From: DaSilva, Luis [REDACTED]
Sent: 26 April 2019 13:50
To: Planning.Responses
Subject: planning application consultation.- WA/49/18/PL

Your Ref
WA/49/18/PL
Our Ref
PLAN-027490
Date
26/04/2019

Proposal: Demolition of existing dwelling & erection of 1 No. replacement dwelling (amendment to WA/49/18/PL).
Site: The White Cottage, West Walberton Lane, Walberton, BN18 0QS.
WA/49/18/PL

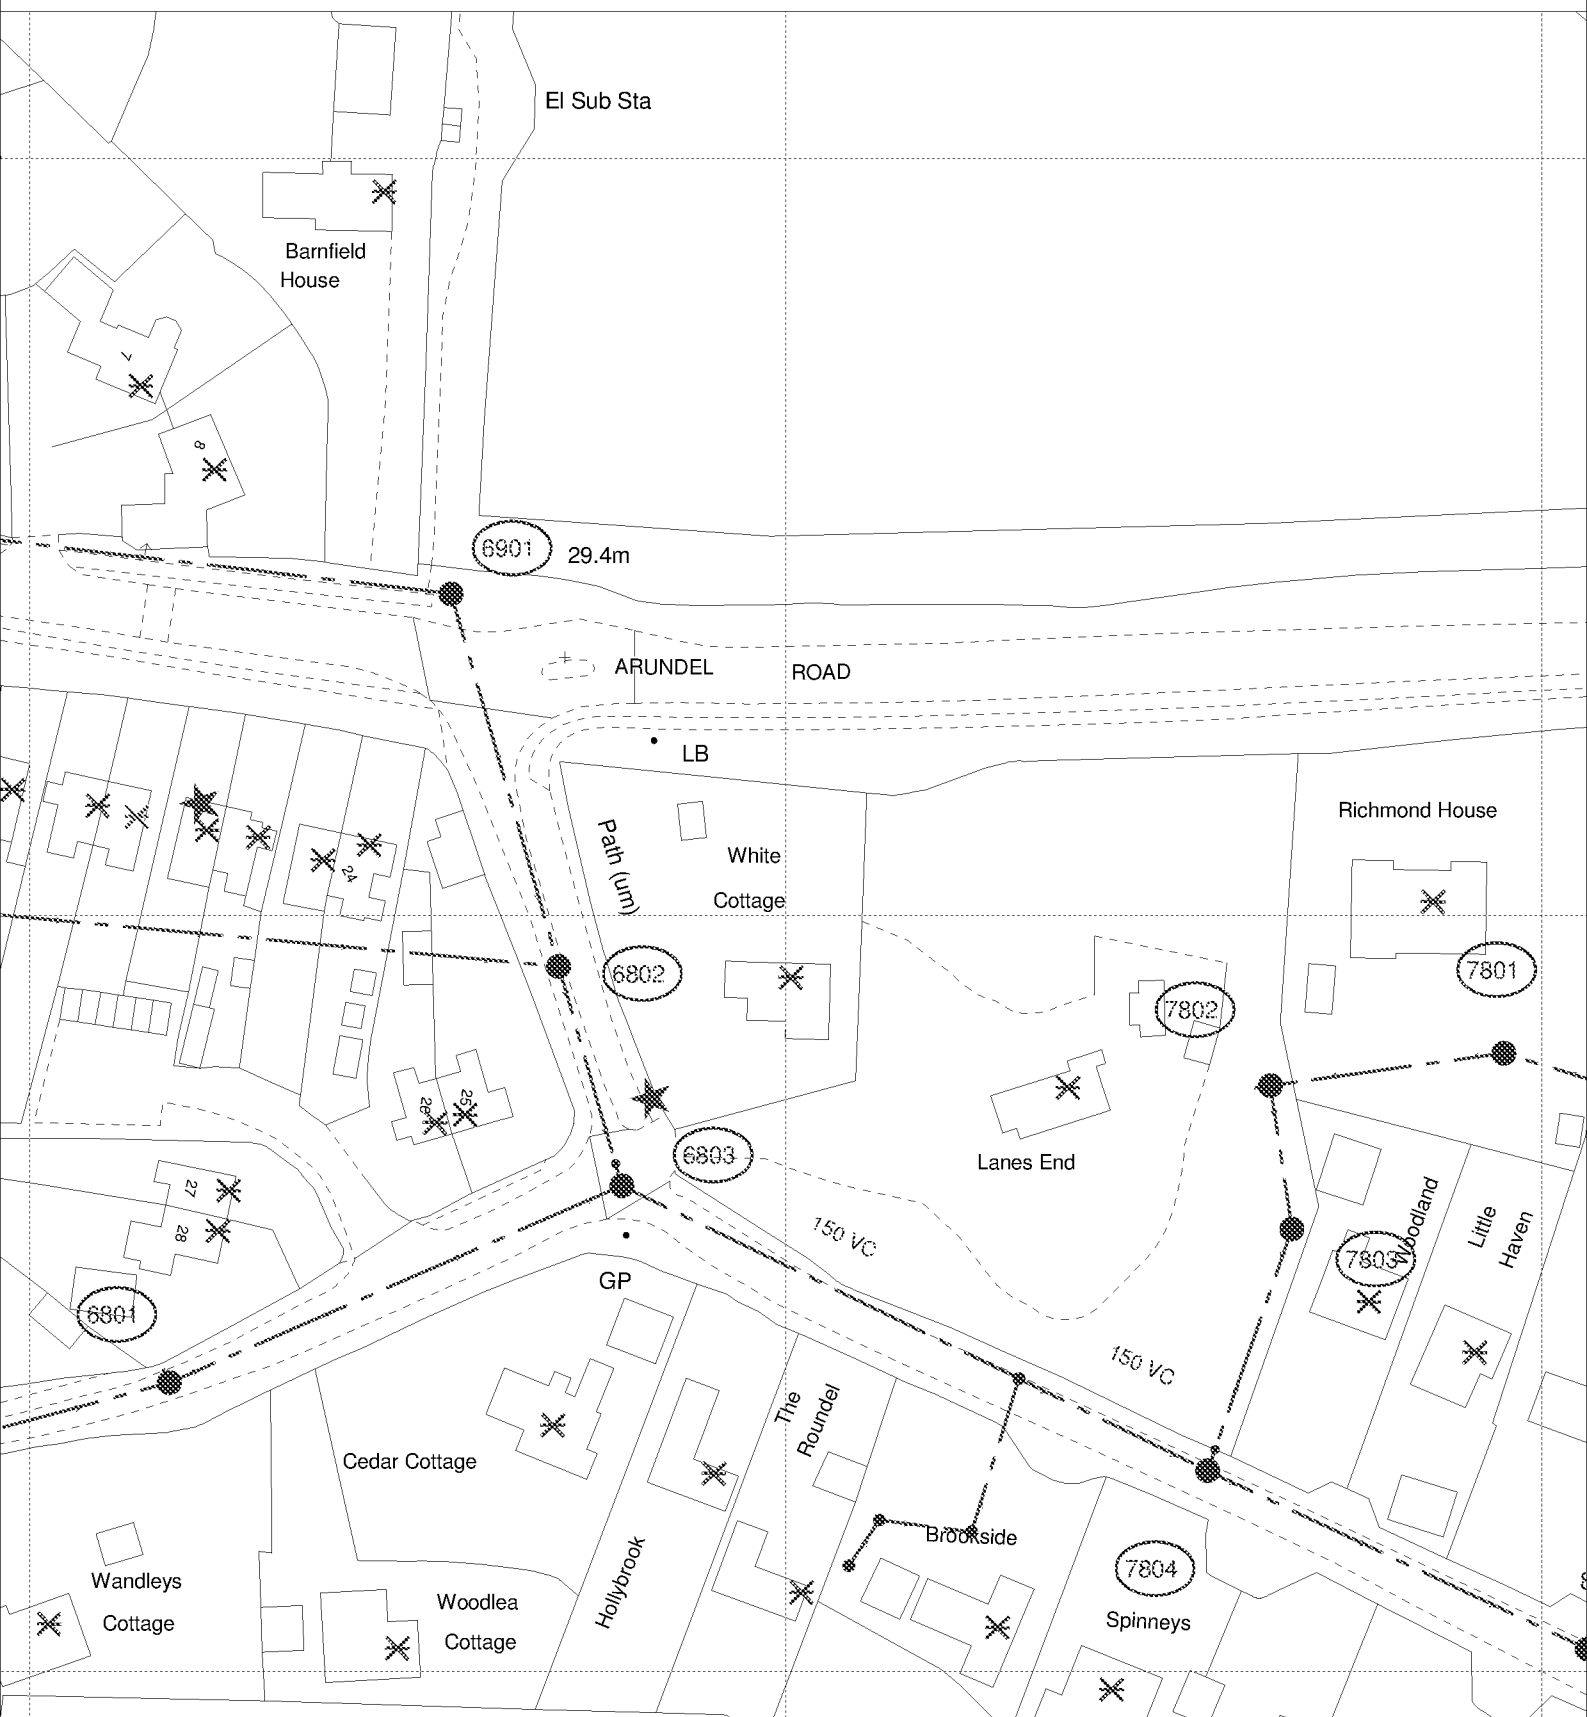
Due to surface water inundation issues in the Lidsey Catchment "The applicant is advised to adopt, where appropriate, the measures in the table "Practical measures to reduce the potential impacts of development".

Developer should look to protect the public sewerage system from inundation and infiltration, which contribute to flooding in unfavourable conditions.
